Draft Informal document GRSP-62-15
(62nd GRSP, 11 - 15 December 2017,
agenda item 3(a))

Draft amendment 2 – Revision 1

Submitted by the Informal Working Group on global technical regulation No. 9

Figure 27
Flexible lower legform impactor: Test set-up for the dynamic lower legform impactor certification test (pendulum test, see paragraph 8.1.2.4.)

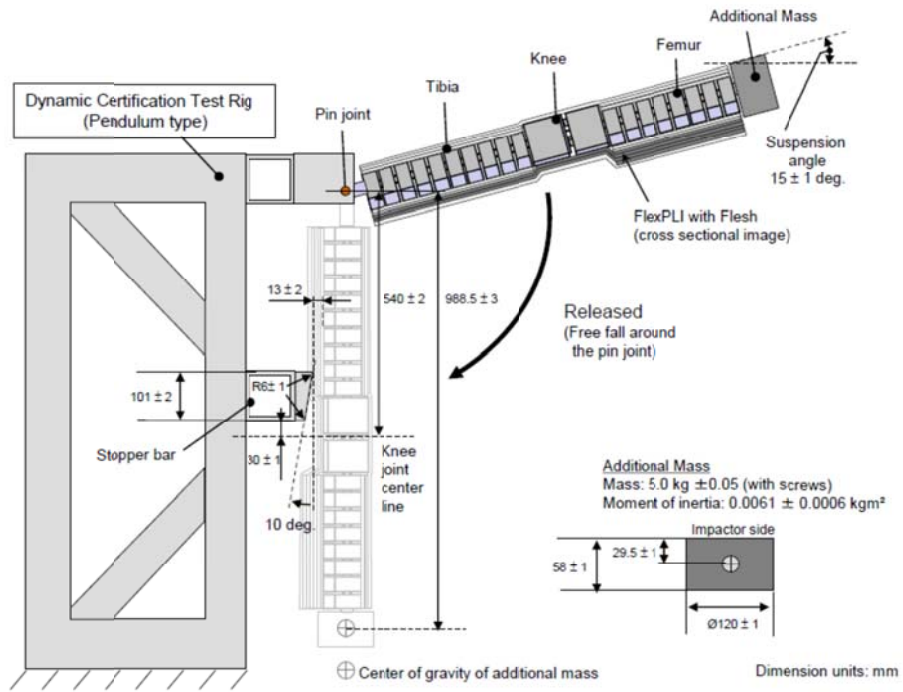
- 8.1.2.4.1. **The flexible lower legform impactor, including the flesh and skin, shall be suspended from the dynamic certification test rig $15 \pm 1^\circ$ upward from the horizontal as shown in Figure 27. The impactor shall be released from the suspended position and fall freely against the pin joint of the test rig as shown in Figure 27.**

~~The impactor, including foam covering and skin, shall be suspended horizontally by three wire ropes of 1.5 ± 0.2 mm diameter and of 2000 mm minimum length, as shown in Figure 22. It shall be suspended with its longitudinal axis horizontal, with a tolerance of $\square 0.5^\circ$, and perpendicular to the direction of the certification impactor motion, with a tolerance of $\square 2^\circ$. The impactor shall have the intended orientation about its longitudinal axis, for the correct operation of its knee joint, with a tolerance of $\pm 2^\circ$. The impactor must meet the requirements of paragraph 6.3.1.1., with the attachment bracket(s) for the wire ropes fitted.~~

- 8.1.2.4.2. **The knee joint centre of the impactor shall be 30 ± 1 mm below the bottom line of the stopper bar, and the tibia impact face without the flesh and skin shall be located 13 ± 2 mm from the front upper edge of the stopper bar when the impactor is hanging freely as shown in Figure 27.**

Figure 28

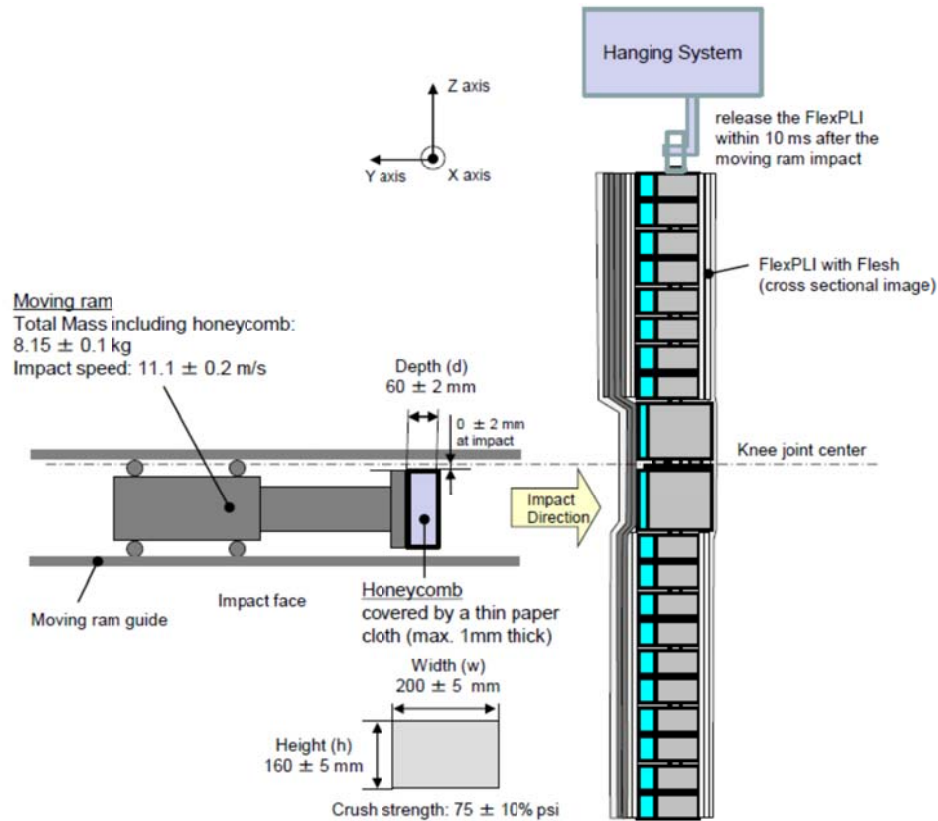
8.1.3.4.1. The assembled flexible lower legform impactor (with the flesh and skin) shall be hung vertically and freely suspended from a test rig as shown in Figure 28. It is then impacted by the upper edge of a linearly guided aluminium honeycomb impactor, covered by a thin paper cloth with a maximum thickness of 1 mm, at an impact speed of $11.1 \pm 0.2 \text{ m/s}$. The legform shall achieve a free flight condition within 10 ms after the time of first contact of the honeycomb impactor.

- 8.1.3.4.4. At the time of the first contact, the flexible lower legform impactor pitch angle (rotation around the Y-axis) and, therefore, the pitch angle of the velocity vector of the honeycomb impactor shall be within a tolerance of $\pm 2^\circ$ in relation to the lateral vertical plane. The flexible lower legform impactor roll angle (rotation around the X-axis) and, therefore, the roll angle of the honeycomb impactor shall be within a tolerance of $\pm 2^\circ$ in relation to the longitudinal vertical plane. The flexible lower legform impactor yaw angle (rotation around the Z-axis) and, therefore, the yaw angle of the velocity vector of the honeycomb impactor shall be within a tolerance of $\pm 2^\circ$.**
